STAFF RECOMMENDATION

2701 Natchez Trace

February 17, 2016

Application: New construction—addition; Setback determination

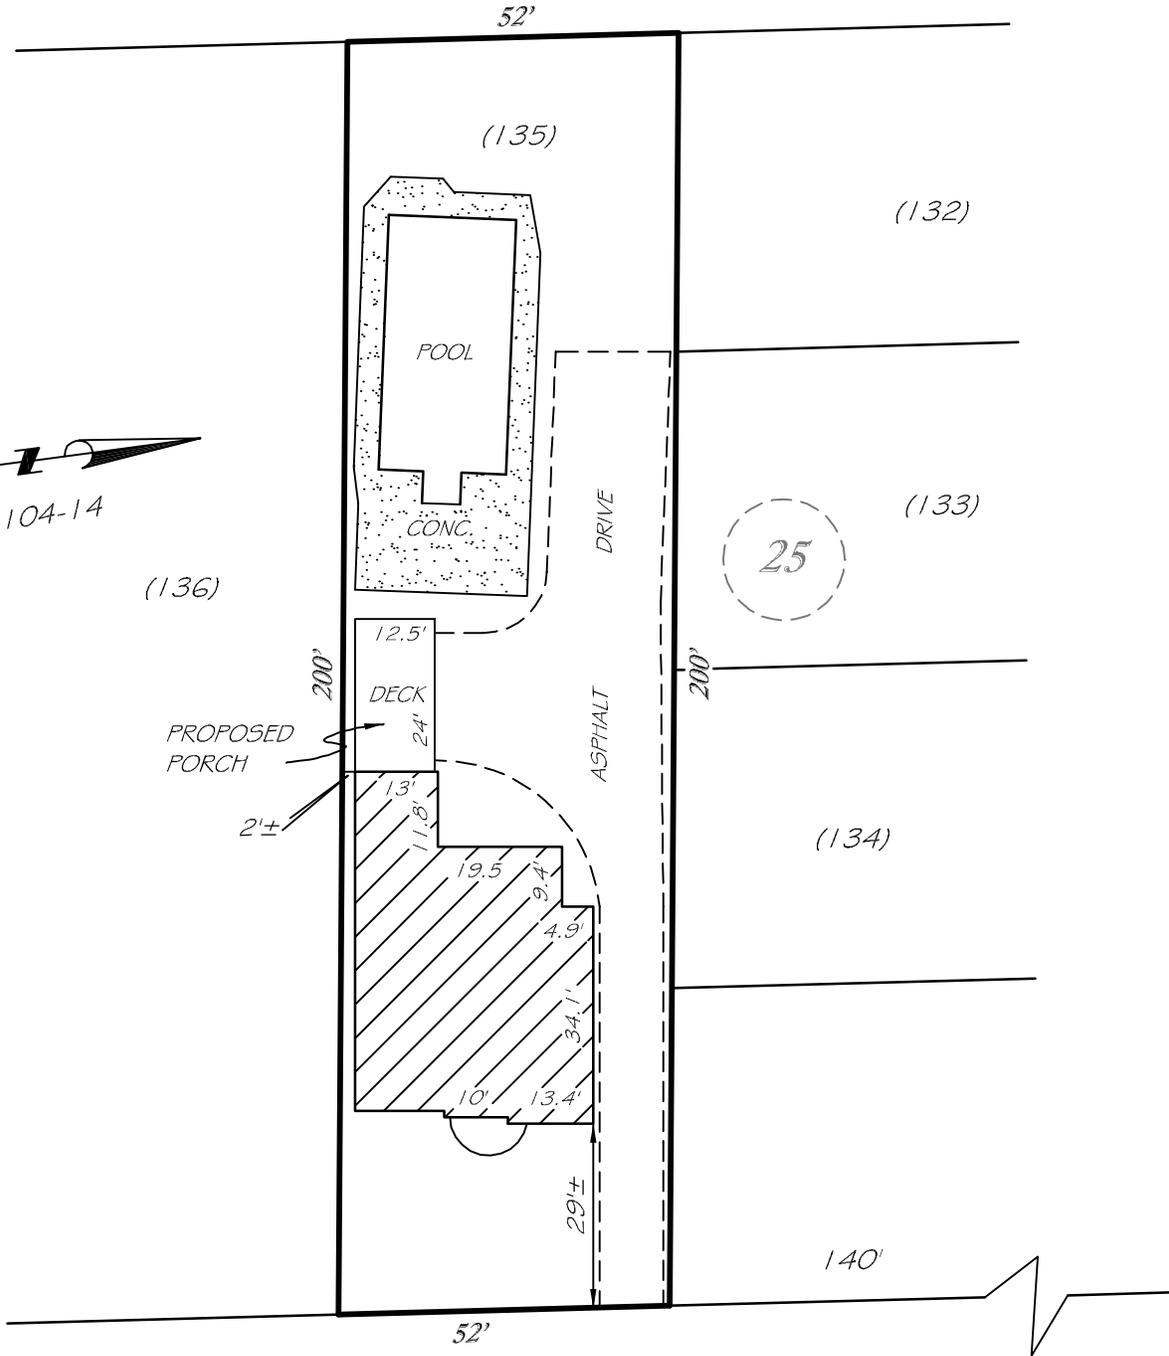
Design: The proposed screen porch is distinguished from the house by its wood and screen materials and its separate roof form. At the same time the addition's height and scale, materials, roof form, and openings are compatible with the historic character of the house. Staff finds that the proposed rear porch meets Sections II.B.2.a and f. of the design guidelines.

Setback & Rhythm of Spacing: The proposed addition requires a setback determination. Base zoning requires that additions be five feet (5') from the side property lines. The proposed rear porch will be located just two feet (2') from the left/south side property line. Staff finds the proposed two foot (2') setback to be appropriate because the existing house is located just two feet (2') from the left/south property line, and the addition will not encroach any further than the existing house. In addition, the proposed porch will be built upon an existing deck that also does not meet the five foot (5') setback and instead is located just two feet (2') from the side property line. Staff finds that the proposed setbacks meet Sections II.B.1.c. and II.B.2. of the design guidelines.
